City of El Paso – City Plan Commission Staff Report
REVISED

Case No:	PZST12-00015
Application Type:	Special Permit
CPC Hearing Date:	November 15, 2012
Staff Planner:	Michael McElroy, 915-541-4238, *mcelroyms@elpasotexas.gov*
Location:	2413 Tremont
Legal Description:	Lots 9 through 14, Block 25, Third Amended Map of Highland Park Addition, City of El Paso, El Paso County, Texas
Acreage:	0.413 acres
Rep District:	2
Zoning:	S-D (Special Development)
Existing Use:	Vacant
Request:	Infill development / Reduction in front, rear, and side setback / 50% parking reduction
Proposed Use:	Apartments
Property Owner:	Hector Barraza
Representative:	Jorge Avila

ATTACHMENT 3: DETAILED SITE DEVELOPMENT PLAN

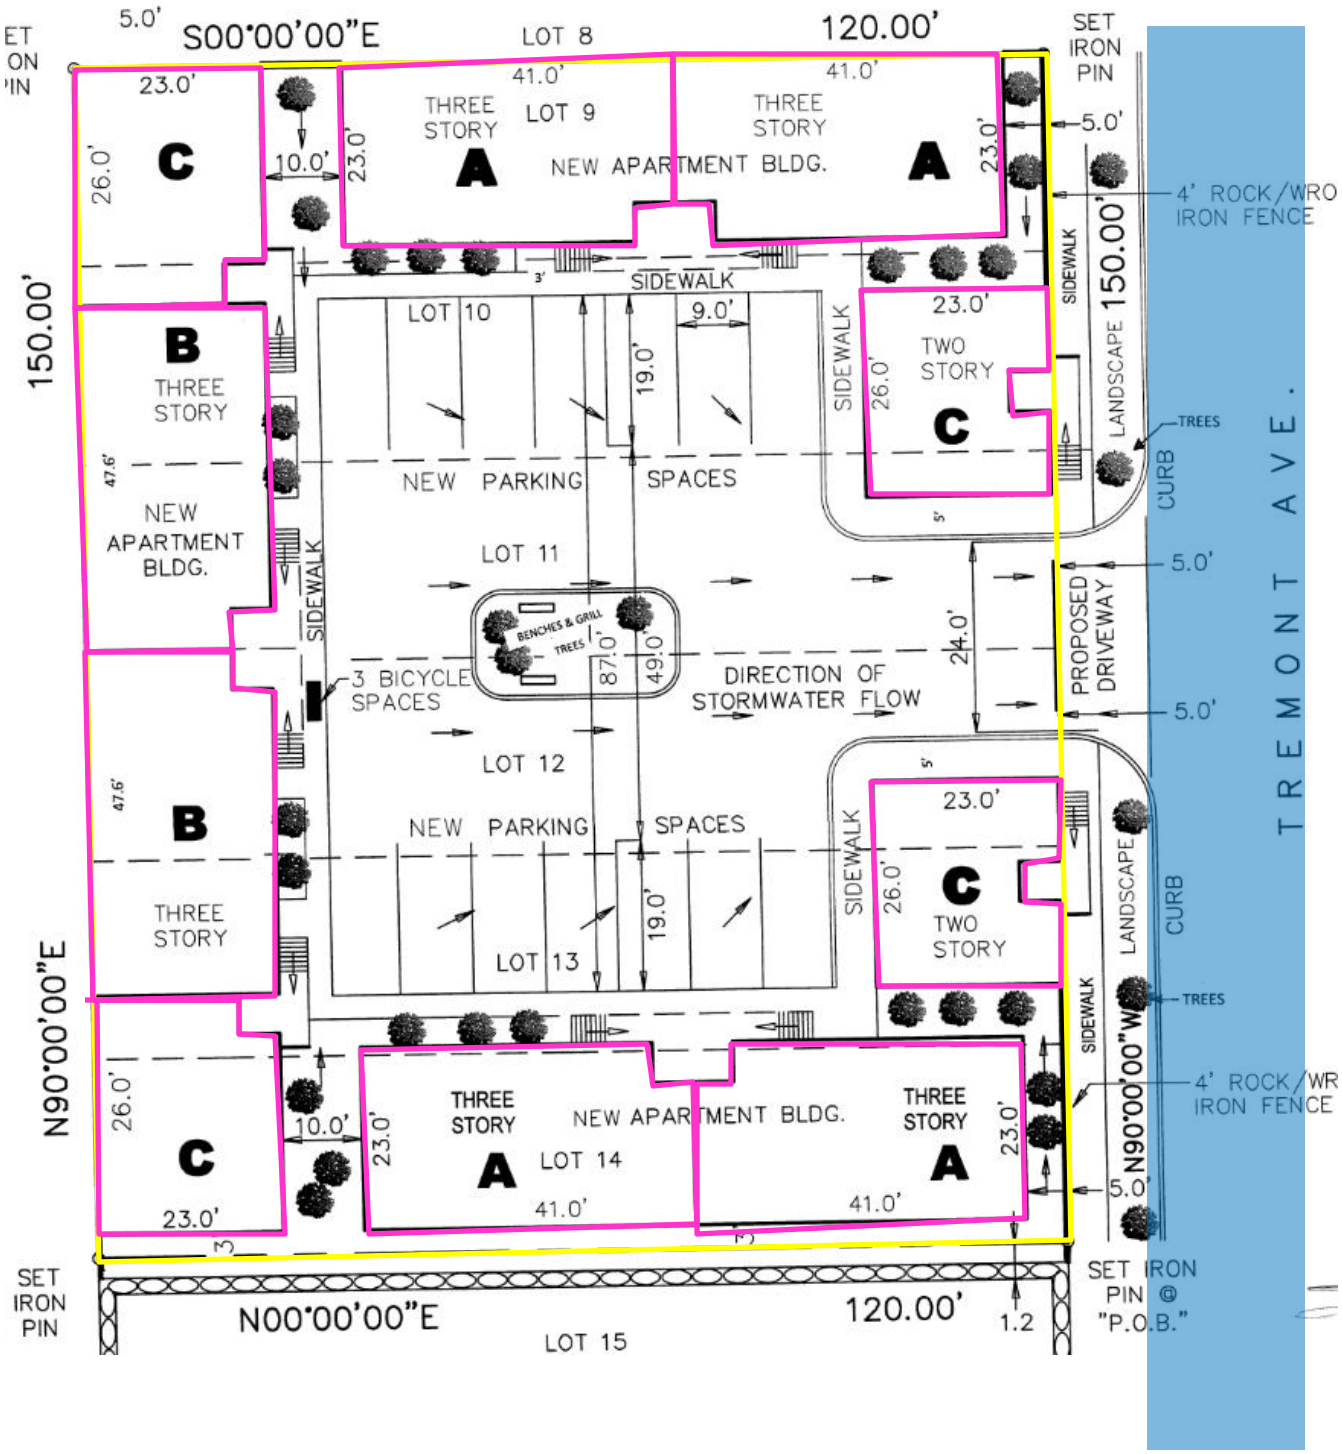
1. The location does not comply with Section 20.10.010.C (legal access required). Tremont Avenue is not constructed adjacent to the proposed development.
2. Improvements to Tremont are required to provide access to the site.
3. The proposed new sidewalk shall continue across the proposed driveway.

D105.3 Proximity to building. At least one of the required access routes meeting this condition shall be located within a minimum of 15 feet (4572 mm) and a maximum of 30 feet (9144 mm) from the building, and shall be positioned parallel to one entire side of the building. Ensure prior to any construction that IFC 2009, section 503.1.1 Access shall allow the extension within 150 feet of all portions of any facility or building. Section 503.2 Fire apparatus access roads shall be installed and arranged in accordance with section 503.2.1 Fire apparatus access roads shall have an unobstructed width of not less than 20 feet, all weather surface. ** Note, A more detailed reviewed will be done by fire plan review during the permitting process.

2. There is an existing 4-inch diameter water main that is available for service along the alley between Dakota and Kentucky Streets. The water main is located approximately 16-ft north from the northern property line.

Sanitary Sewer:
5. There is an existing 8-inch diameter sanitary sewer main along Tremont Avenue that is available for service, the sewer main is located approximately 1-ft south from the center line of the right-of-way.

6. The El Paso Water Utilities – Public Service Board (EPWU-PSB) requires a complete set of improvement plans, and grading plans for review and approval prior to any work along Tremont Avenue East of Dakota Street fronting the subject property. This is required in order to ascertain that the proposed improvement and/or grading will not adversely affect the existing eight inch diameter sanitary sewer main.
